**Project: IEEE P802.15 Working Group for Wireless Personal Area Networks
(WPANs)**

Submission Title: comment resolution assignment

Abstract: proposes comment resolutions for a set of CIDs

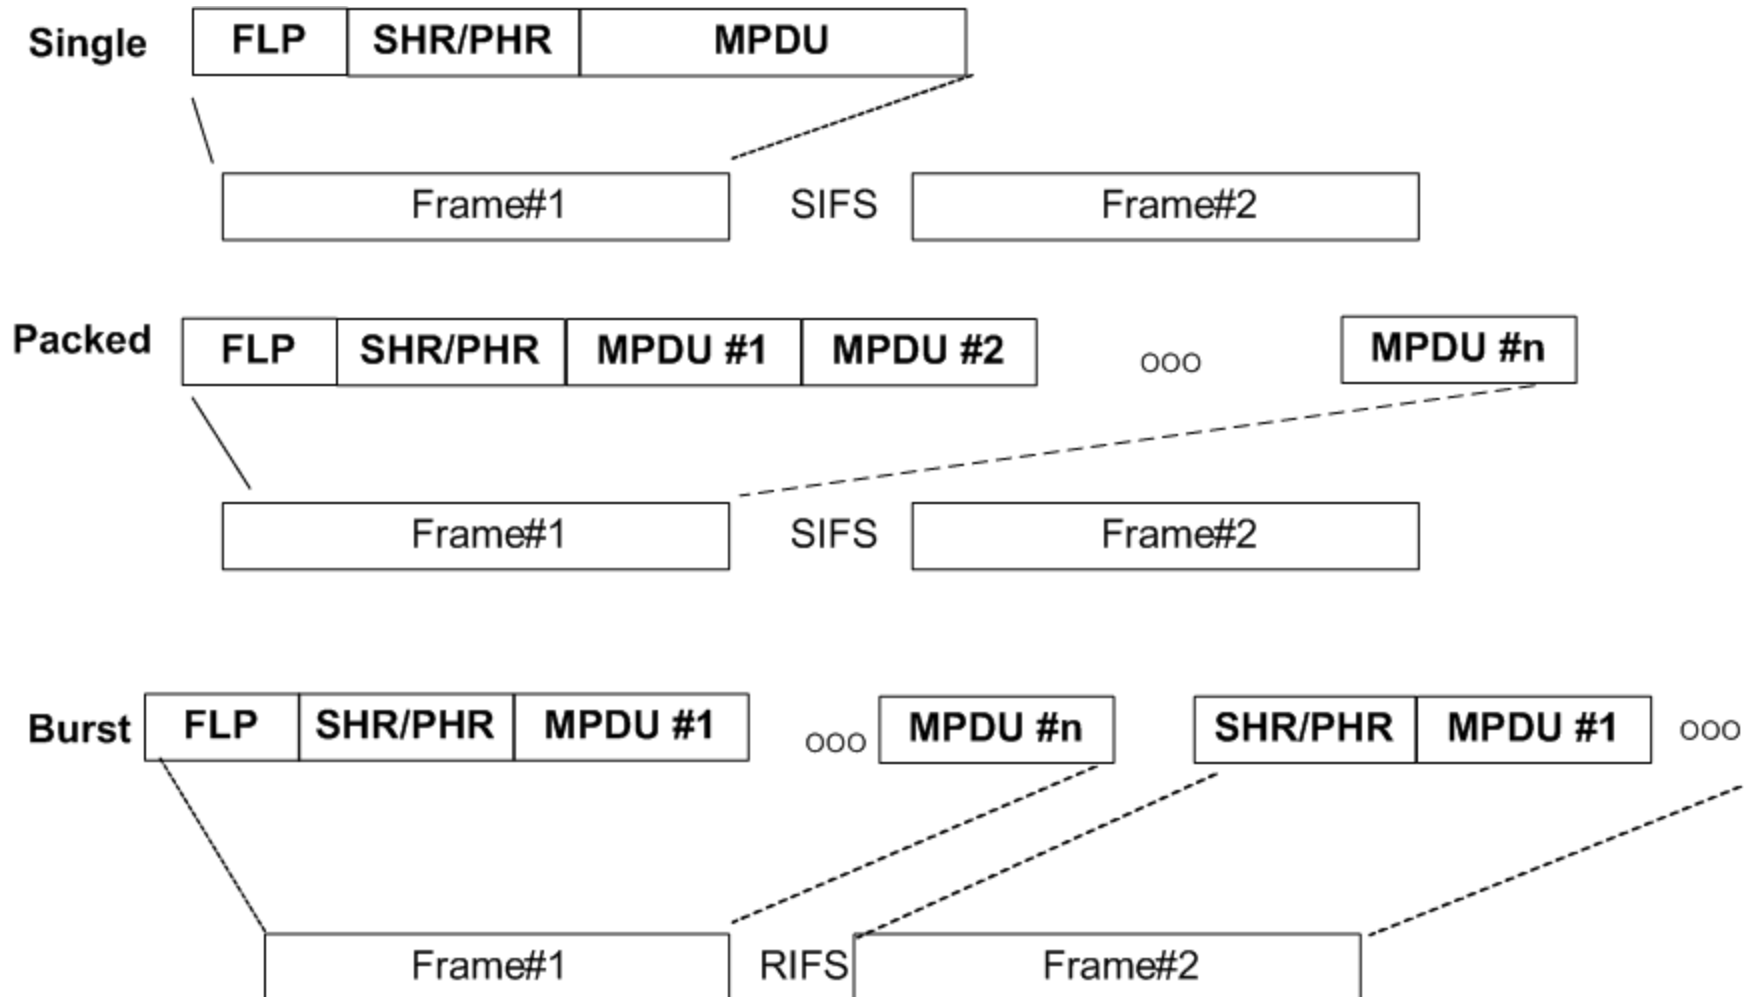
- In Figure 20, in Burst mode, there are two MAC PDU #n. These should be fixed.
- Figure 20 - Burst Mode - shows the same MAC PDU being transmitted twice, in both Frame #1 and #2. This figure does not align with the text
- (SY) In Burst mode, both packets are shown with the label "MAC PDU #n". I believe that the labels should be different

- Redraw the figure with correct PDU numbers.
- replace first MAC PDU #n with MAC PDU #1 and second MAC PDU #n with MAC PDU #2

- Comment accepted in principle. However, fix is not easy.

Instruction to editor: Update Figure 20
